ITEM: 600 Pine Street Landmark, Alteration Certificate, & Grant Request

REQUEST: A request to Landmark 600 Pine Street, and requests for an Alteration Certificate and Preservation and Restoration Grant

Image 14: East elevation. Brick chimney

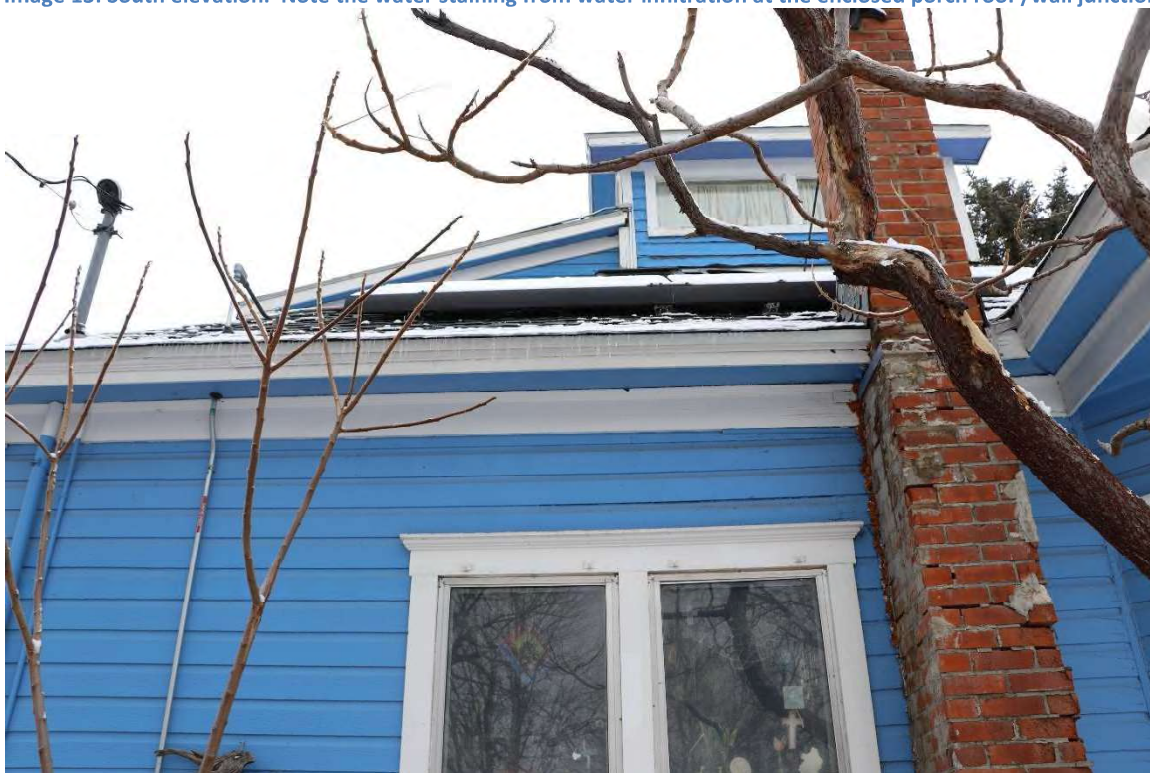
Image 15: Brick chimney base. Advanced deterioration from moisture
